## ADDENDUM NO. 1

February 19, 2024

RE: **Elmira High School Restroom Remodel**

Unisex Restroom Floor Plan

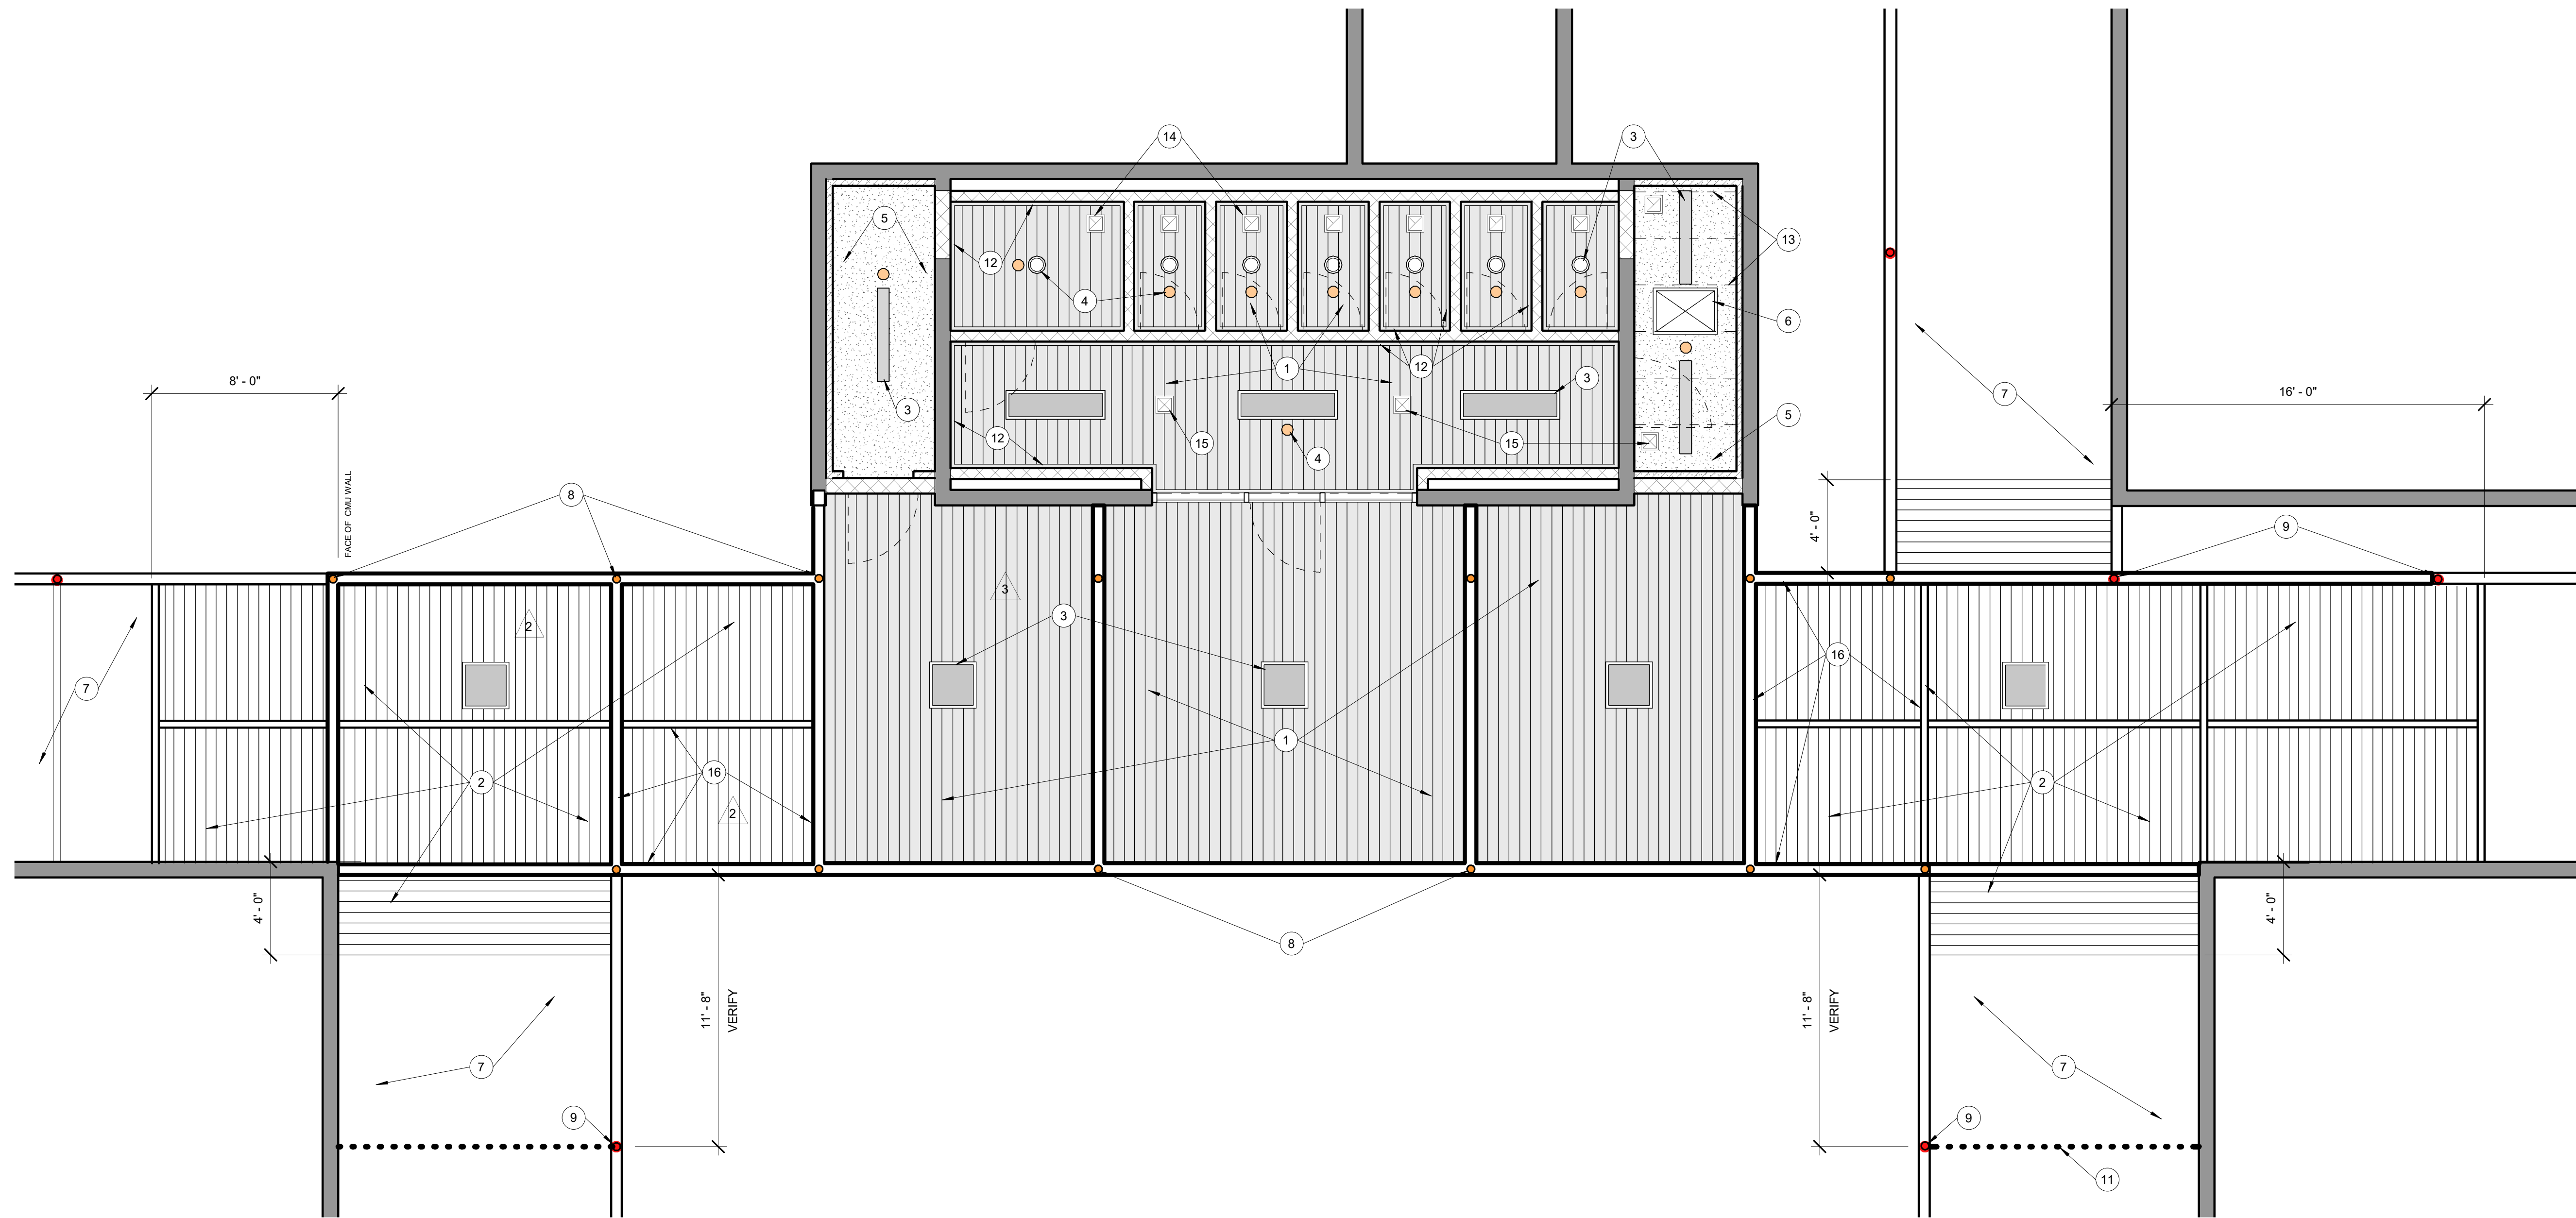
1. Please see attached General Contractor & Subcontractor participant list at mandatory pre-bid meeting held on February 14, 2024.
2. Replace Floor Plan sheet A1.2 & Reflected Ceiling Plan sheet A1.3 with attached revised sheets A1.2 & A1.3. Miscellaneous revisions include: aluminum storefront frame revision, removal of outdated delta changes and revision to A1.2 Keynote Schedule – Note #1.
3. Revise Hardware Group #4 as follows:  
Pull/Push device to be Kawneer storefront offset pull handle & double bend push bar set in lieu of the Rockwood VRP 30. Confirm 'Best' cylinder is compatible with the Kawneer push/pull device.

4. Clear sealer referred to in keynote #1 on sheet A1.2 can be found in specification section, 'Water Repellants' – 07 17 50. The product specified is: Chem-Trete PB VOC by Protectosil/Evonik.
5. Delete the reference to Specification Section 064023 listed in the Table of Contents.
6. See attached substitution request for Fantech SER450.

# SER 450

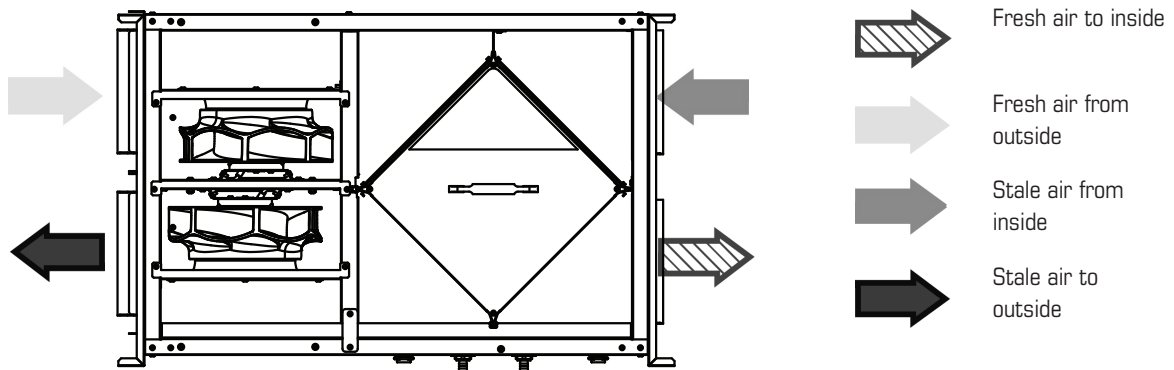
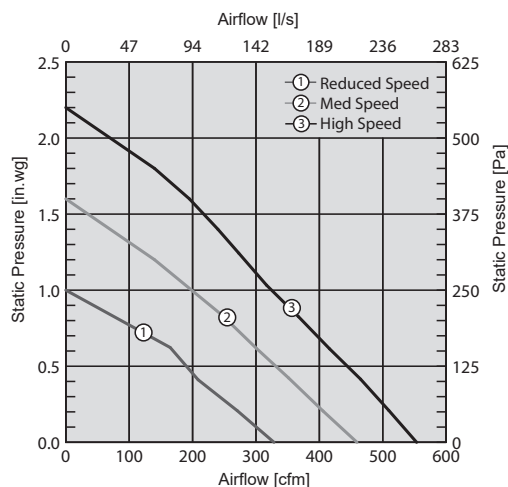
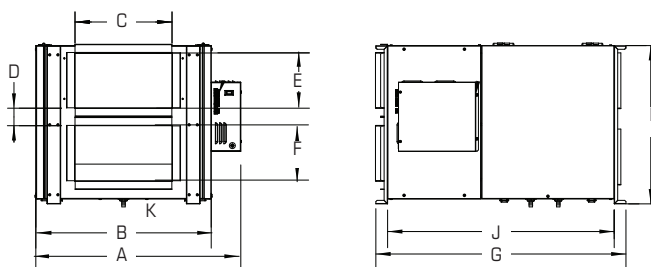
Proposed Substitution: Fantech SER450

- C. What difference exists between proposed substitution and specified item? Unit is 120V
- D. Does substitution affect Drawing dimensions?  
Yes \_\_\_ No ☒  
If Yes, explain Unit may differ in size but should be substantially similar

☒ Not Accepted ☐ Received Too Late

Remarks SER 450 fan capacity  
inadequate for project.  
SER 700 is too wide for  
space
